**Subject: Green Ridge Recycling and Disposal Facility, LLC
Notice of Intent and Part A Application – Technical Review**

The Virginia Department of Environmental Quality (DEQ) Piedmont Regional Office (PRO) is in receipt of a Notice of Intent (NOI) and Part A Permit Application for the Green Ridge Recycling and Disposal Facility, LLC, dated January 17th and received on January 22, 2020. Additional information was received by the Department April 16, 2020 and October 28, 2020 regarding Disclosure Statements, January 08, 2021 regarding the Demonstration of Need, and February 16, 2021 regarding Public Water Supplies. The NOI and Part A Permit Application, and supplemental information, was prepared by Draper Aden Associates, LLC, on behalf of the Green Ridge Recycling and Disposal Facility, LLC.

049007 - Flippen Dam - Landfill Site

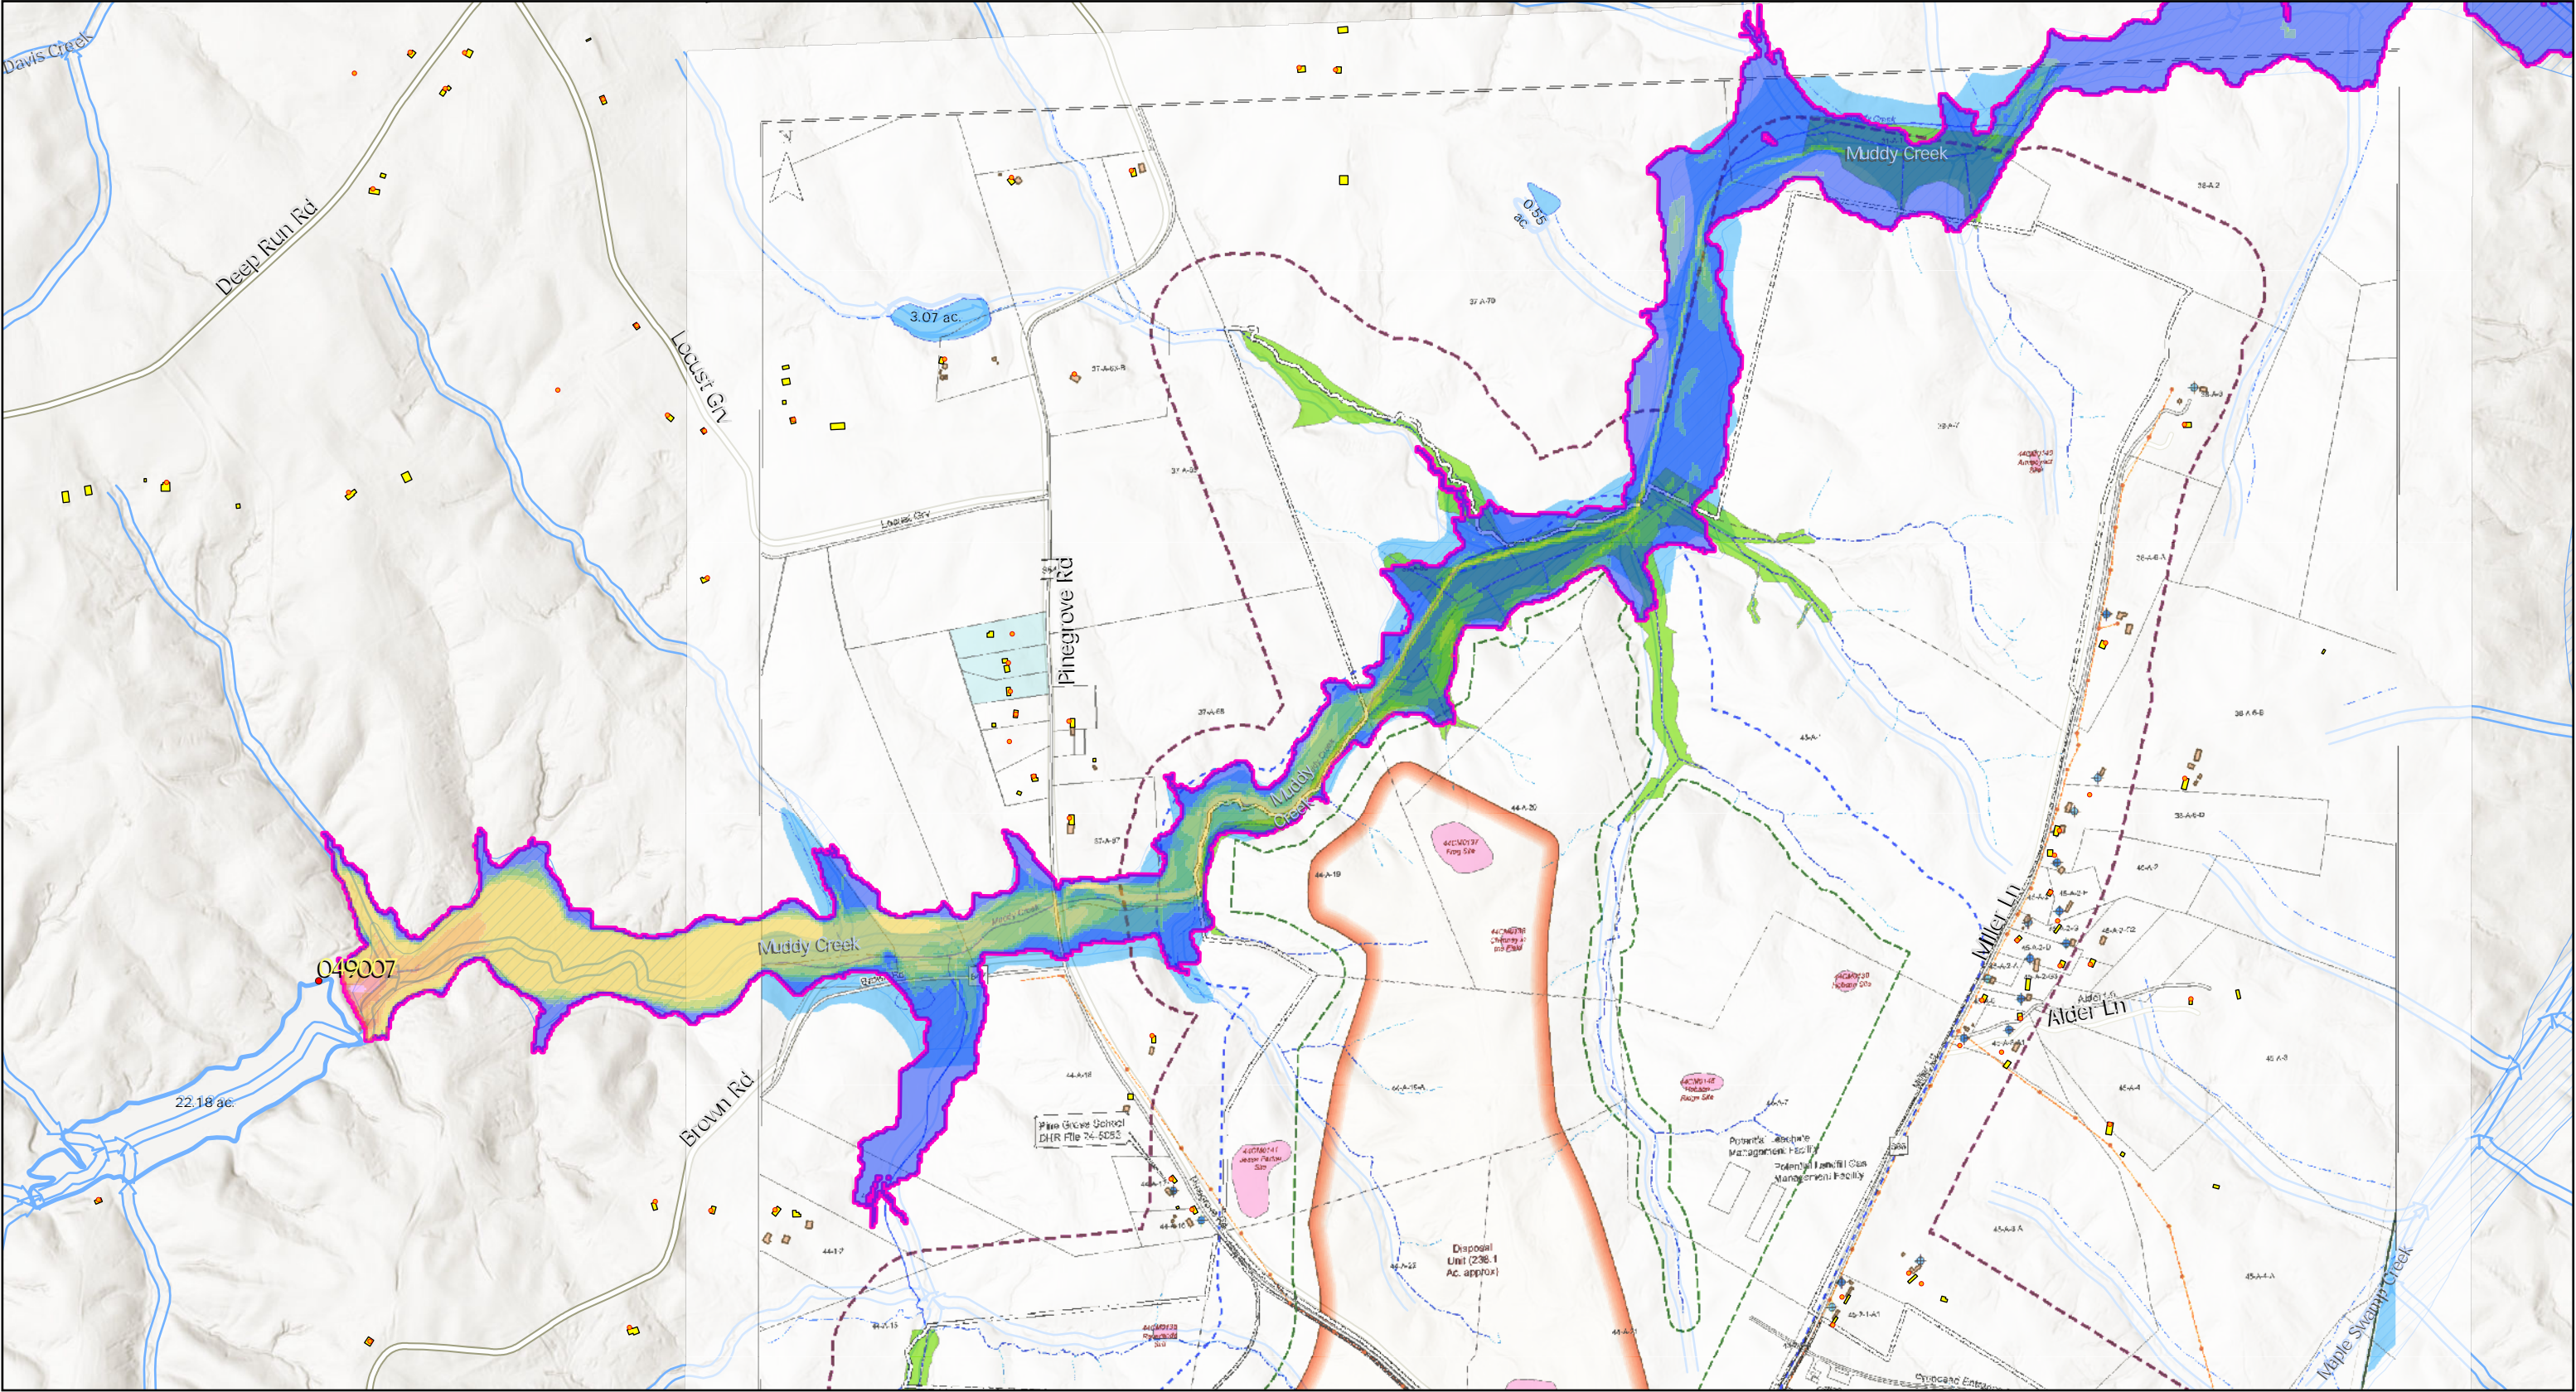
- 8.) The Department of Conservation and Recreation has performed a simplified dam break analysis based upon the maximum storage capacity of Flippen Dam along Muddy Run. Their analysis (attached) indicates that the proposed waste management boundary encroaches into the dam break inundation zone. Please revise the waste management boundary or provide additional documentation that the waste management boundary will not encroach into the dam break inundation zone.

Flippin Dam (049007) is along Muddy Creek just west of the proposed project site and has an estimated maximum storage capacity of 366 acre-feet and a height of 22 feet from the natural streambed. The dam is used for agricultural purposes and since its height is less than 25 feet it has an agricultural exemption from the Virginia Impoundment Structure Regulations, and, therefore, not required submit a formal dam break inundation study. However, DCR has performed a simplified dam break analysis based on the maximum capacity of the dam and it appears that the proposed waste management boundary does encroach in to the dam break inundation zone. Additionally, the 500' waste management boundary is well within the dam break inundation zone throughout much of the northern end of the project site. See attached overlay of the proposed project site drawing with the DCR provided dam break inundation zone. There are no other known regulated impoundment structures within the proposed project vicinity.
